ADDENDUM No. 3

**ORG #207 – San Jacinto Elementary School - Renovation
ORG #273 – Pleasant Grove Elementary School – Renovation**

DALLAS INDEPENDENT SCHOOL DISTRICT

11/01/2024

PARTIAL PLUMBING ROOF PLAN 'B2'

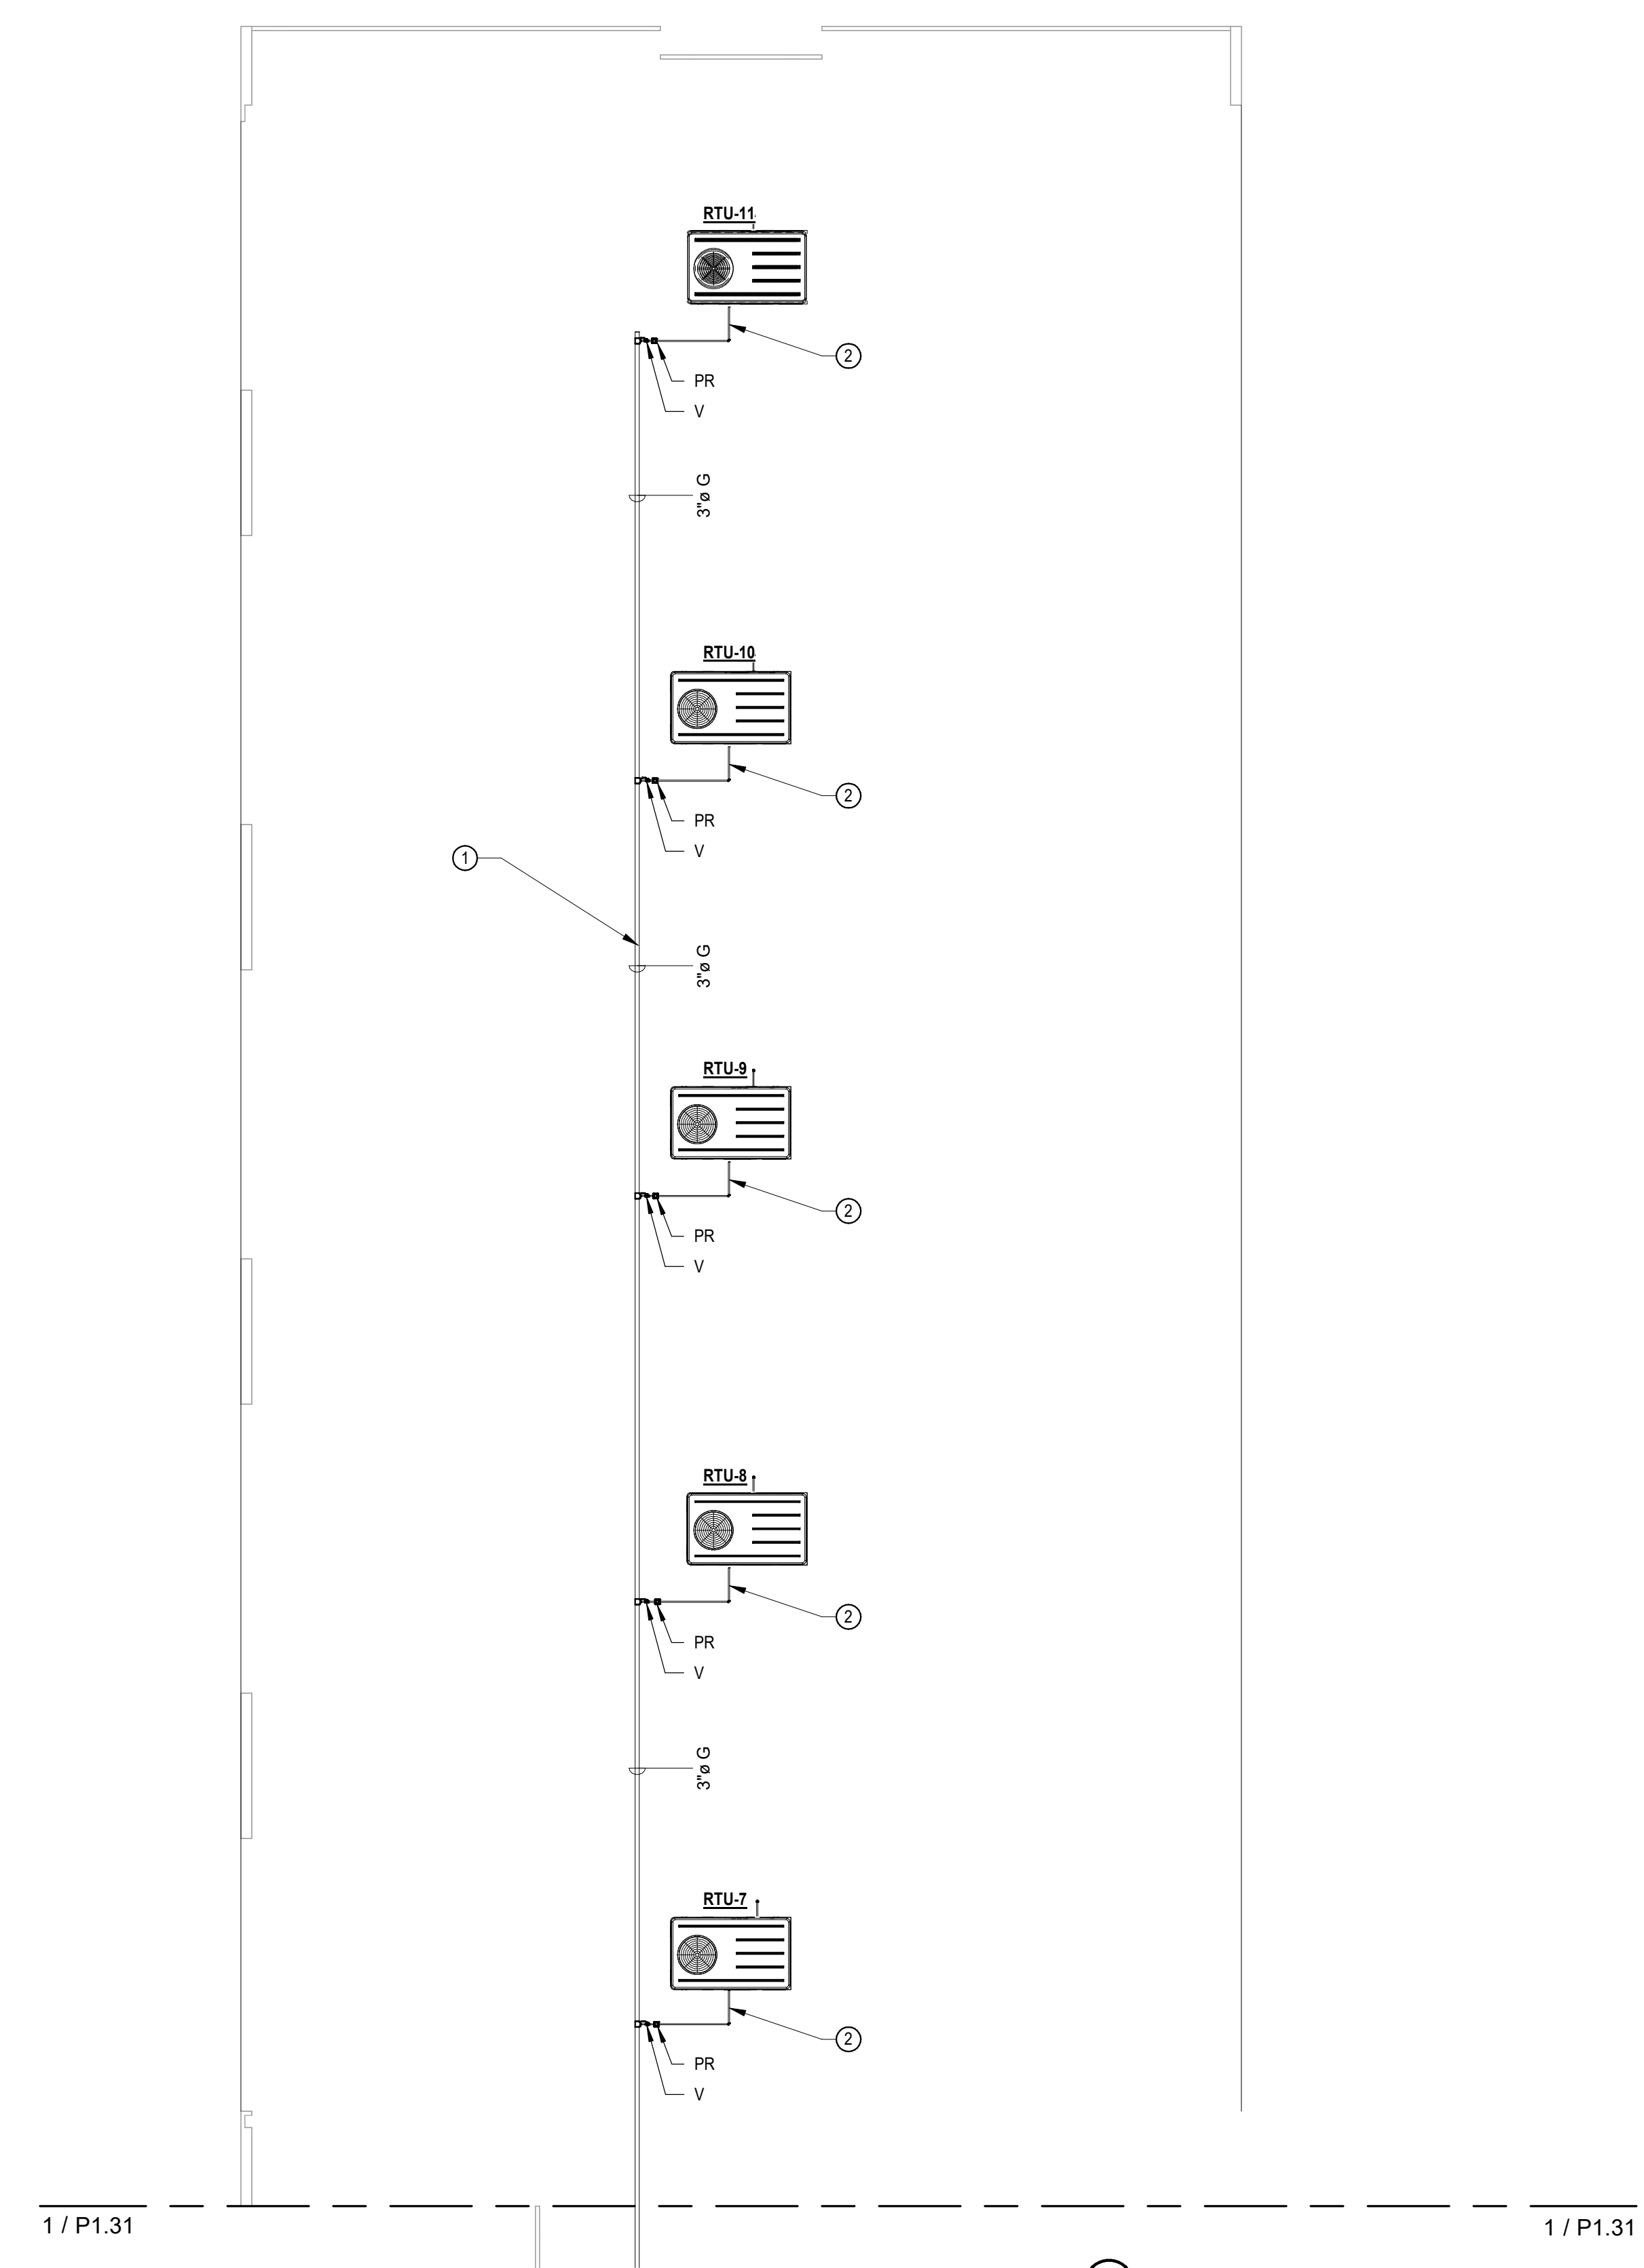
- Updated note #1 to include painting of new gas piping as indicated.
- Replace sheet with the revised attached C3.00.
 - Fence scope removed as indicated.

1 PROVIDE NEW GAS PIPING AND ROOF SUPPORTS. PROVIDE NEW GAS PIPING AT SAME SIZE AS EXISTING. FIELD VERIFY EXACT SIZE OF GAS PIPING PRIOR TO INSTALLATION. GAS PIPING TO BE PAINTED. COLOR TO BE APPROVED BY ARCHITECT.

MARQUEE SIGNAGE & DETAILS

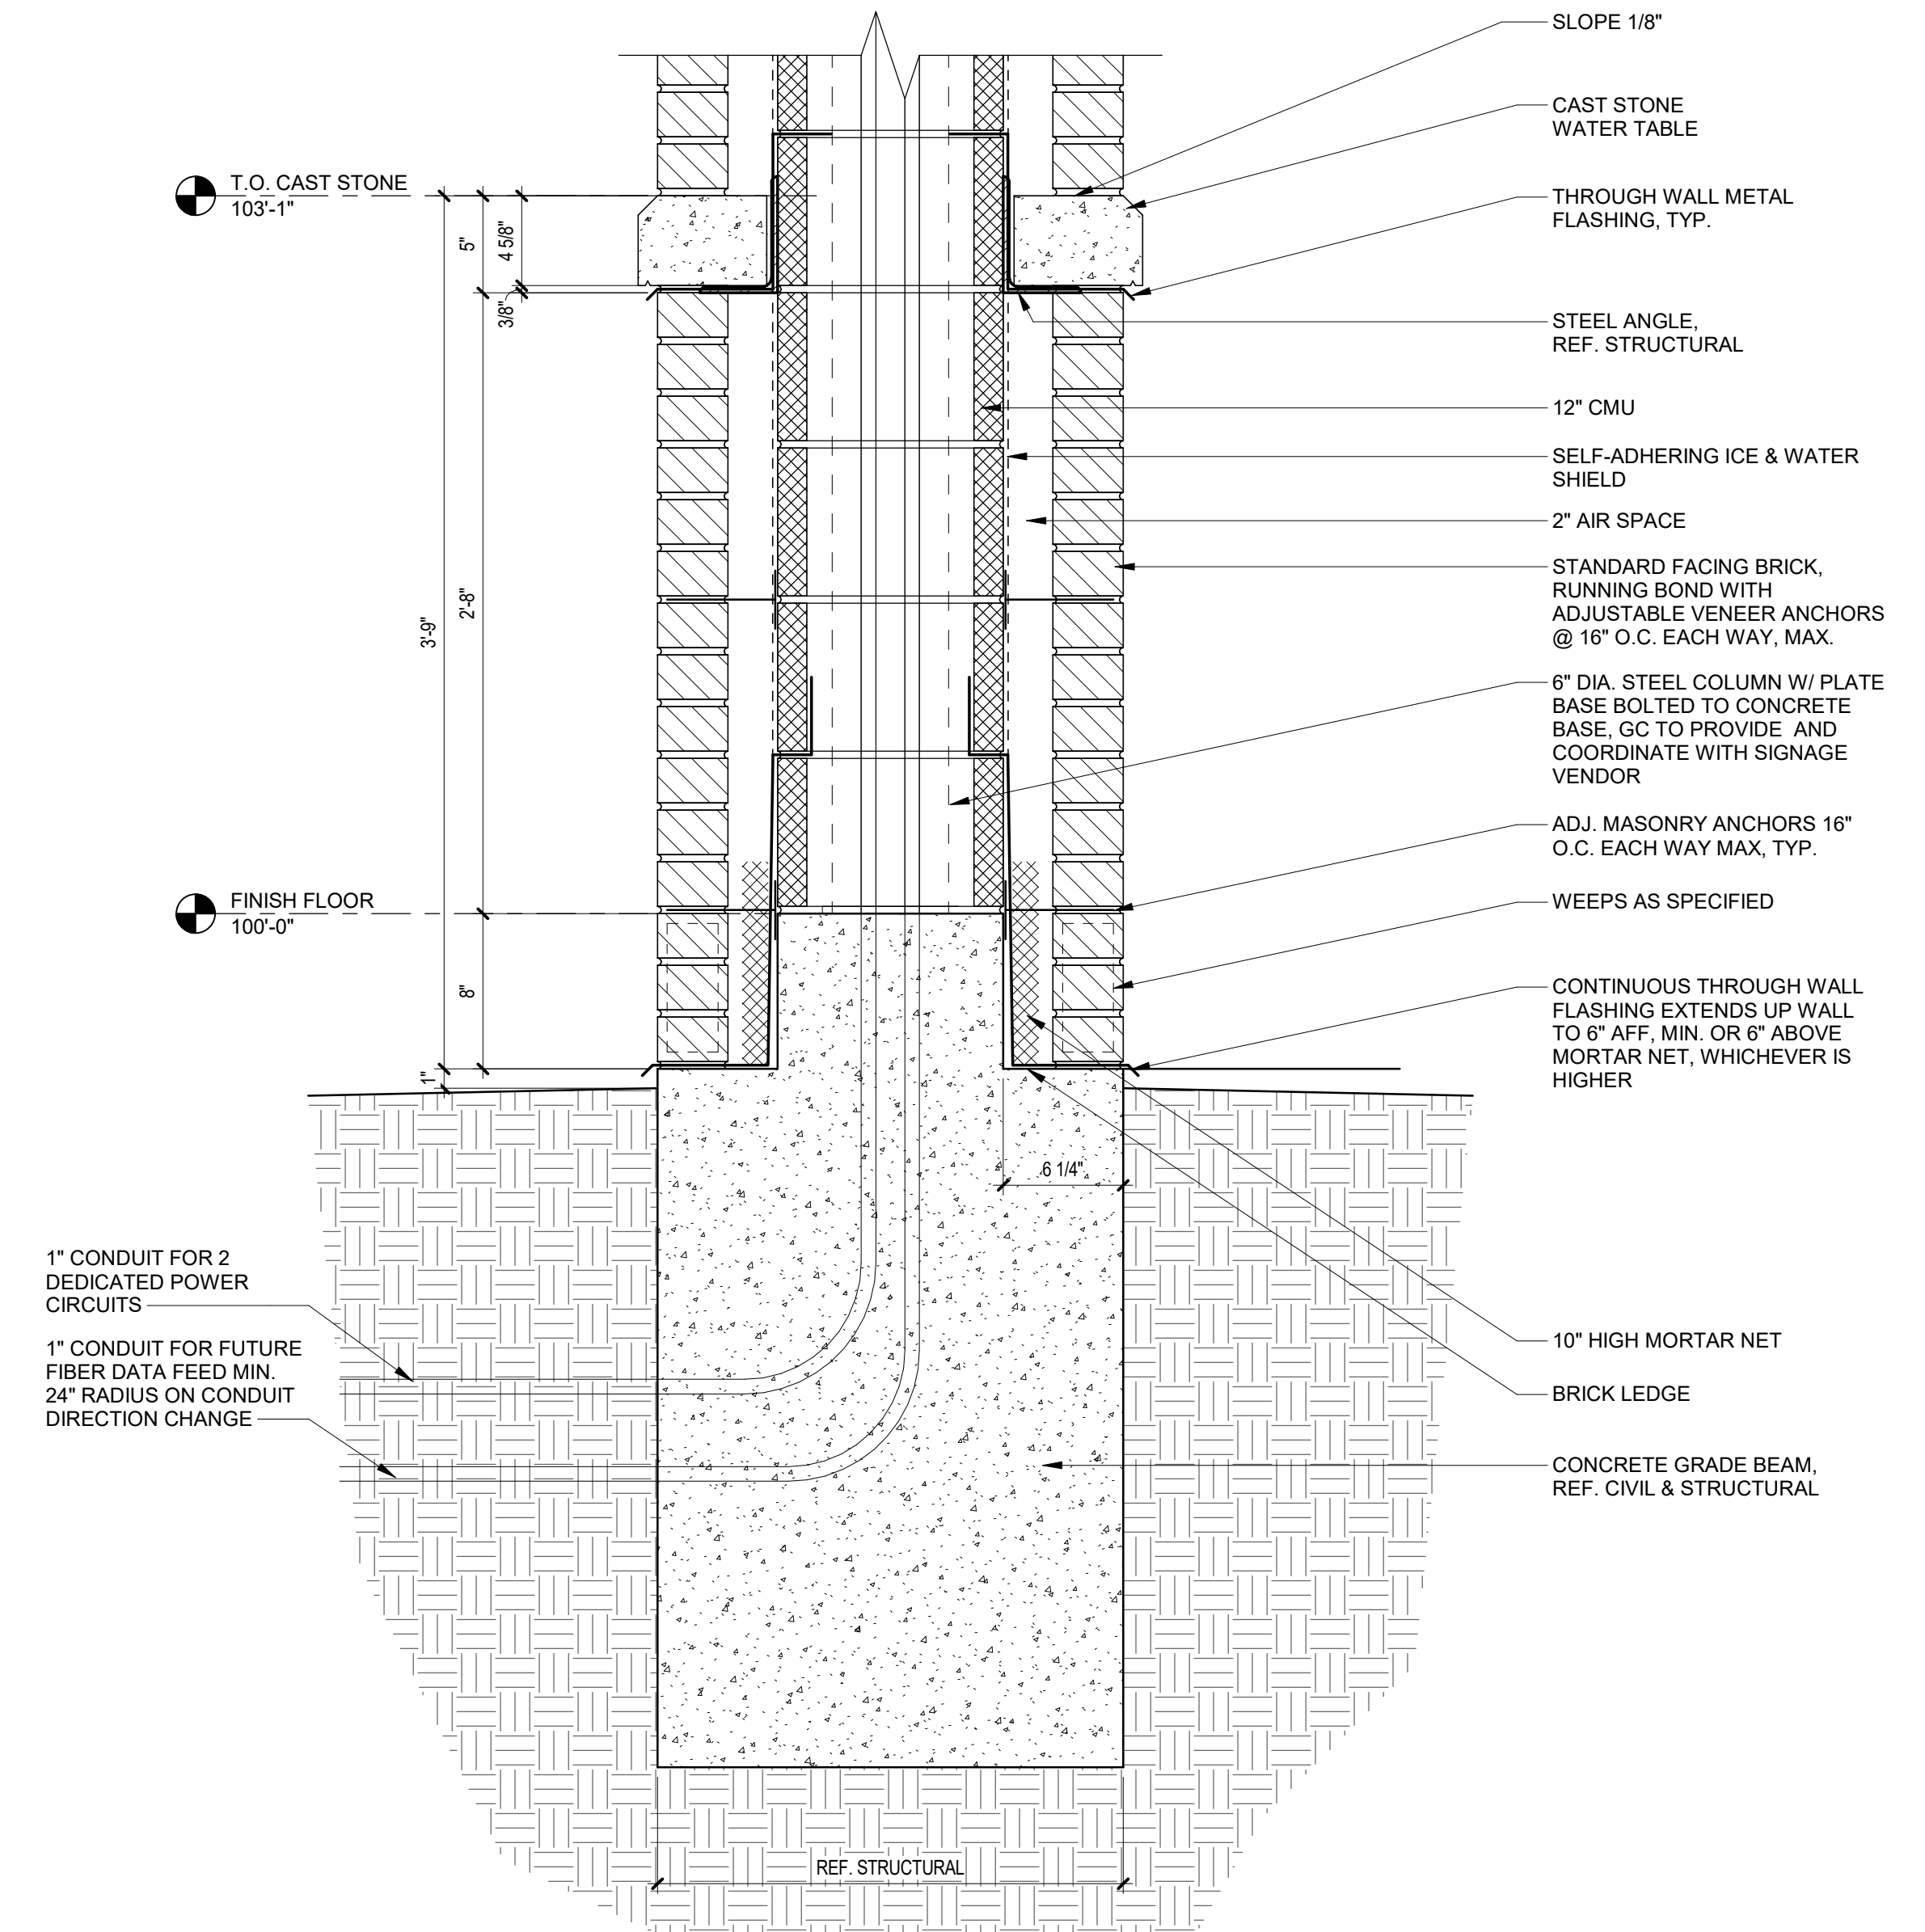
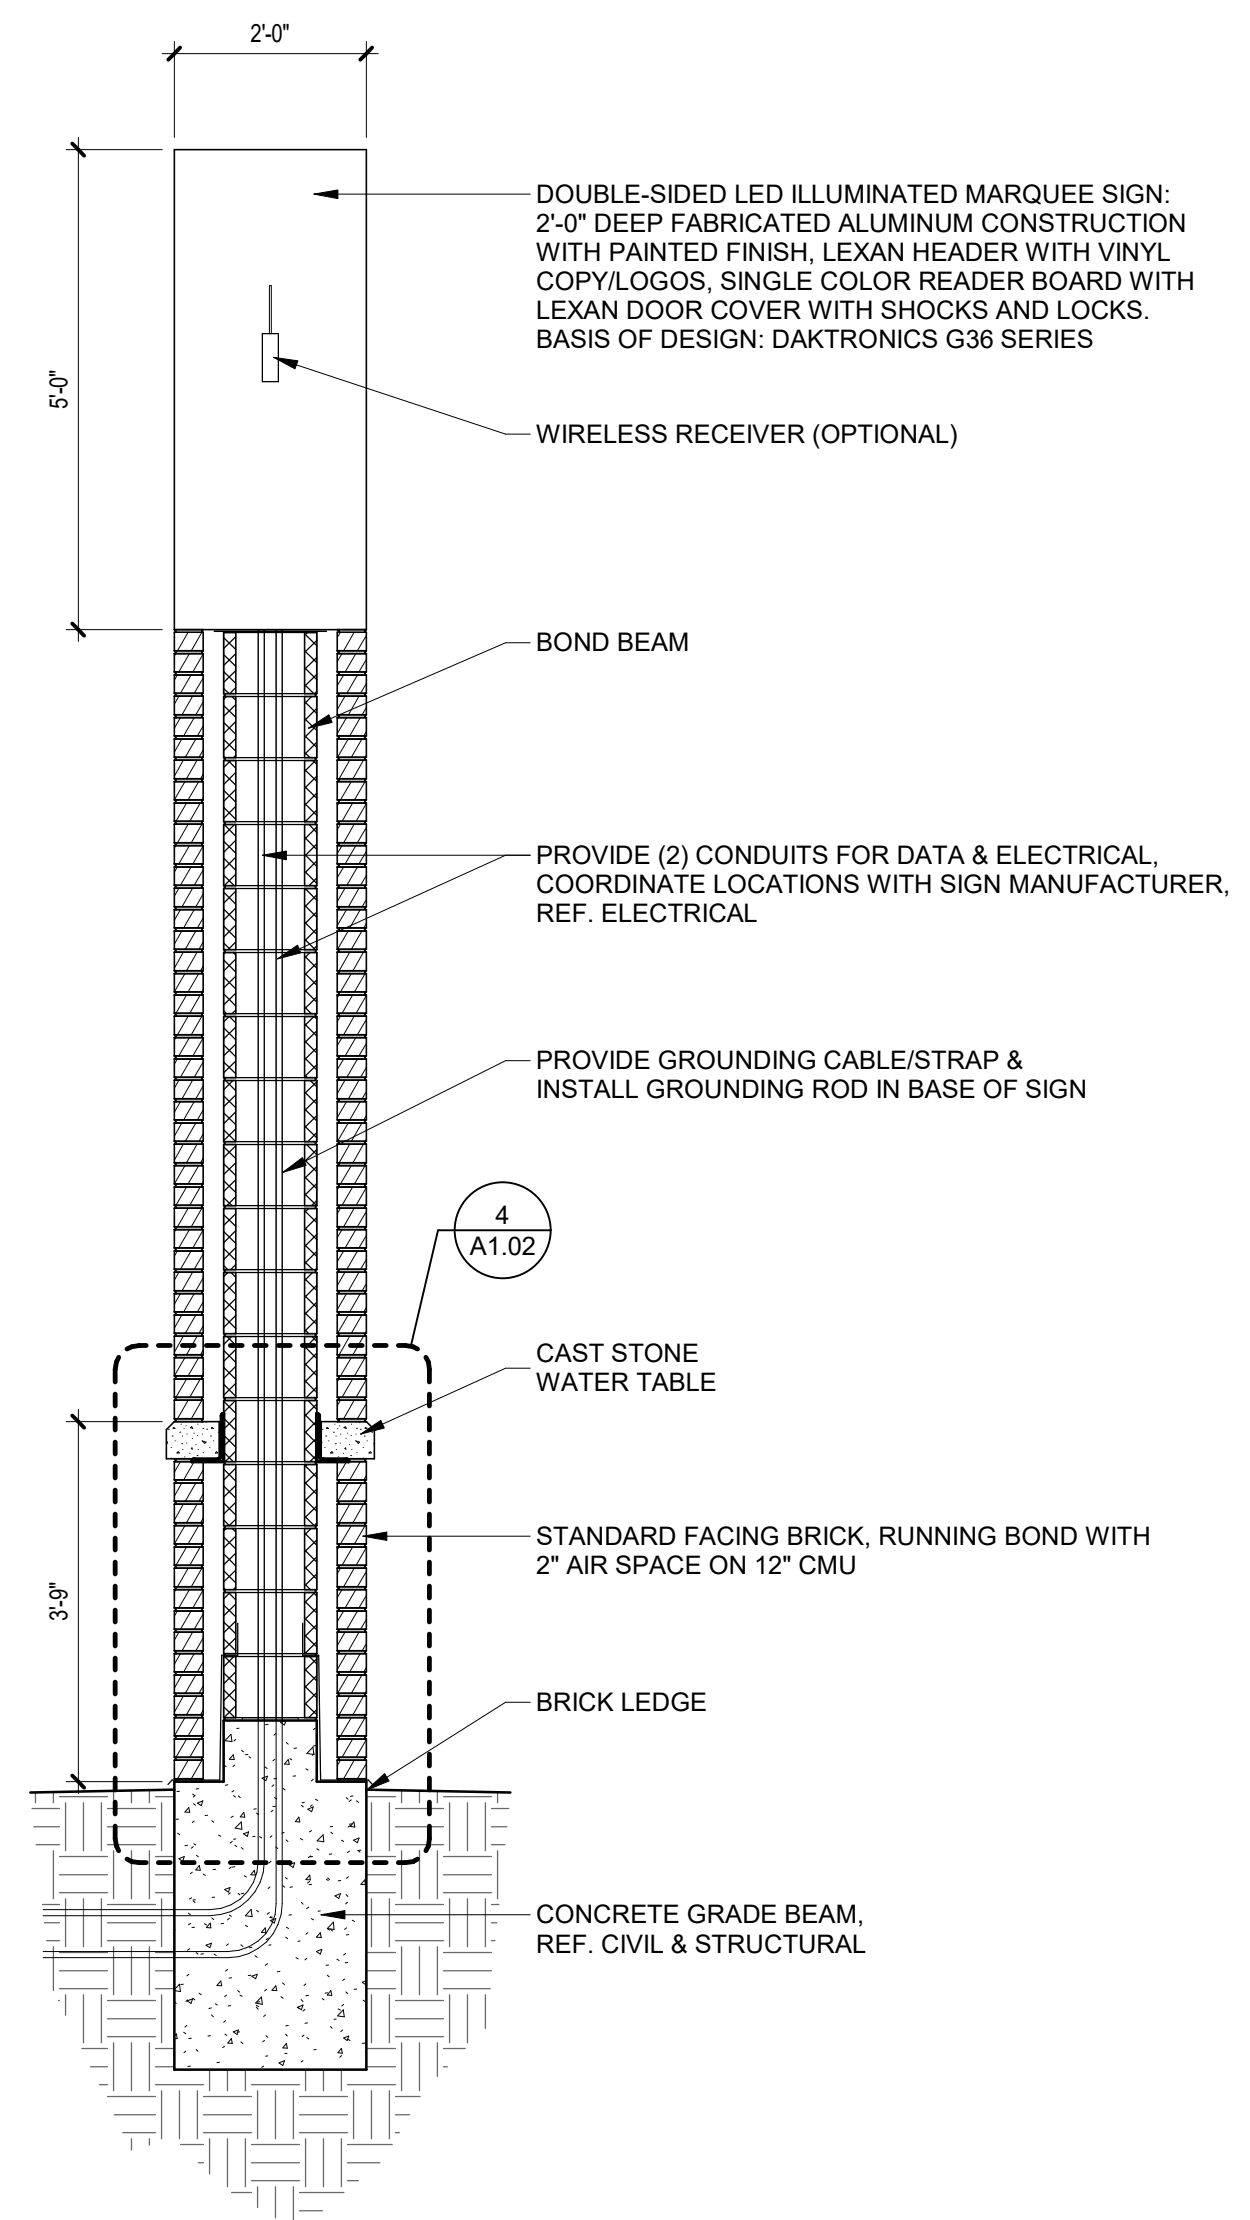
- Replace sheet with the revised attached A1.02.
 - Add note: Ensure UPN fiber running into building will not be affected by marquee excavation. If UPN fiber needs to be relocated, notify DISD.
- Replace sheet with the revised attached S2.01.
 - Add note: Ensure UPN fiber running into building will not be affected by marquee excavation. If UPN fiber needs to be relocated, notify DISD.
- Replace sheet with the revised attached R1 and R2
 - Add note: If there are adjustments to the existing roof openings or conflicts with the existing structure regarding roof top units, contact the Architect/EOR.

1. REFER TO MEP FOR ALL ELECTRICAL AND DATE REQUIREMENTS.
2. ENSURE UPN FIBER RUNNING INTO BUILDING WILL NOT BE AFFECTED BY MARQUEE EXCAVATION. IF UPN FIBER NEEDS TO BE RELOCATED, NOTIFY DISD.
